McGUIRE NUCLEAR STATION, UNIT 1

AMENDMENT TO FACILITY OPERATING LICENSE

Amendment No. 35  
License No. NPF-9

Amendment No. 16  
License No. NPF-17

Figure 3.9-2  
Minimum Burnup vs. Initial Enrichment  
for Region 2 Storage

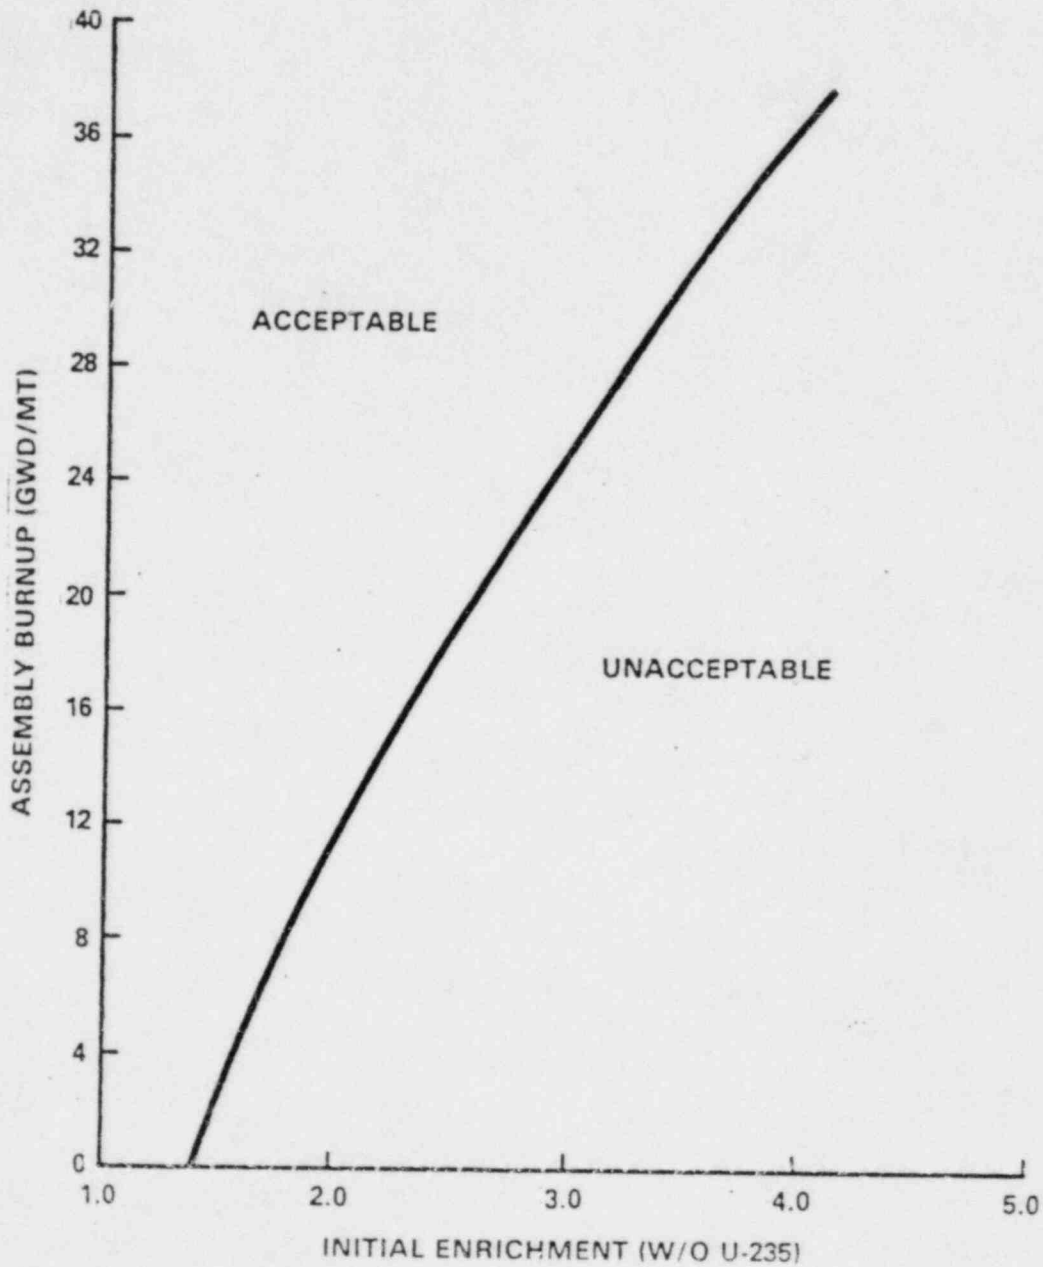
- a. Storage in Region 2 restricted to the following:
  - 1) Fuel which has been qualified in accordance with Figure 3.9-2 or unqualified fuel stored in a checkerboard configuration. In the event checkerboard storage is used, one row between normal storage locations and checkerboard storage locations will be vacant; and
  - 2) Irradiated fuel which has decayed at least 16 days; and
- b. The boron concentration in the spent fuel pool maintained at greater than or equal to 2000 ppm.

- 4.9.12a. Verify all fuel assemblies to be placed in Region 2 of the spent fuel pool are within the enrichment and burnup limits of Figure 3.9-2 by checking the assemblies' design and burnup documentation.
- b. Verify at least once per 31 days that the spent fuel pool boron concentration is greater than 2000 ppm.
